# Access Compliance Report

## Public Rights-of-Way

### (Island Curb Cuts)

Intersection ID: 3125	Main Street: JOHNSTON_OEHLER_RD	Cross Street: MOURNING_DOVE_LN	Location: S
ADA ID: 636702BAD7AF	Curb Cut Type: MedianRefuge2	Initial Pass/Fail: Fail	Overall Compliance: No
Codes/Mitigation Info/Possible Solution		Field Measurements/Component Compliance	
Severity Score: 25

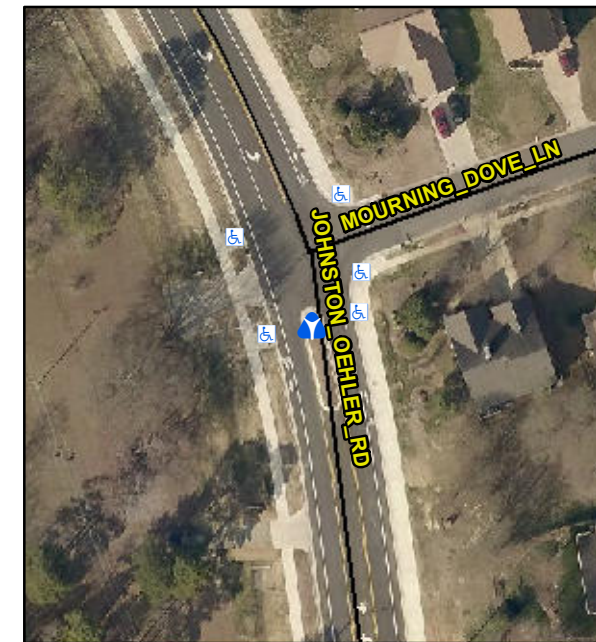
Compliance	Description	Data	Compliance	Description	Data
Yes	Refuge 1 Length (In)	47.0	N/A	Gutter 1 Ponding?	N/A
Yes	Refuge 1 Width (In)	95.0	N/A	Gutter 1 Lip Ht (In)	N/A
No	Refuge 1 Slope (%)	6.2	N/A	Gutter 1 Slope (%)	N/A
Yes	Refuge 1 X Slope (%)	2.2	N/A	Gutter 1 X Slope (%)	N/A
N/A	Painted X Walk1?	No	N/A	DWS 1 Provided?	N/A
N/A	X Walk 1 Direction	To W	N/A	DWS 1 Contrast?	N/A
N/A	X Walk 1 Width (In)	N/A	N/A	DWS 1 Length (In)	N/A
N/A	Road 1 Slope (%)	2.2	N/A	DWS 1 Full Width?	N/A
N/A	Road 1 X Slope (%)	3.0	N/A	DWS 1 Offset (In)	N/A
Yes	Refuge 2 Length (In)	47.0	N/A	Gutter 2 Ponding?	N/A
Yes	Refuge 2 Width (In)	95.0	N/A	Gutter 2 Lip Ht (In)	N/A
No	Refuge 2 Slope (%)	7.2	N/A	Gutter 2 Slope (%)	N/A
Yes	Refuge 2 X Slope (%)	2.5	N/A	Gutter 2 X Slope (%)	N/A
N/A	Painted X Walk2?	No	N/A	DWS 2 Provided?	N/A
N/A	X Walk 2 Direction	To E	N/A	DWS 2 Contrast?	N/A
N/A	X Walk 2 Width (In)	N/A	N/A	DWS 2 Length (In)	N/A

**Remove & Replace Entire Refuge.**
